The Cadillac Serviceman

JUNE, 1957

Fig. 1

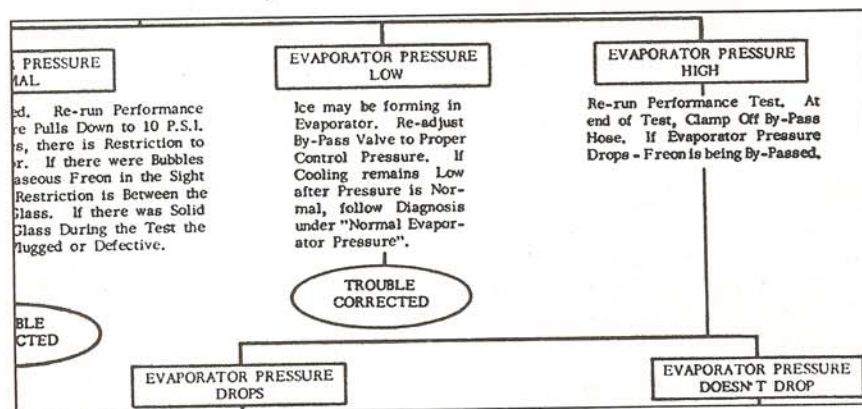
AIR CONDITIONER DIAGNOSIS CHART CORRECTION

A CORRECTION is necessary in the Air Conditioner Diagnosis Chart which appears on Page 13-6 of the Eldorado Brougham Service Information Manual, and in Fig. 4 of the April 24 Serviceman Supplement.

The Diagnosis Chart lists "Trouble Corrected" under "Evaporator Pres-

sure High". However, this is an error, for the chart should indicate "Trouble Corrected" under "Evaporator Pressure Low", as shown in Fig. 1.

To assure an accurate air conditioner diagnosis, Servicemen should make this correction in the above mentioned publications.
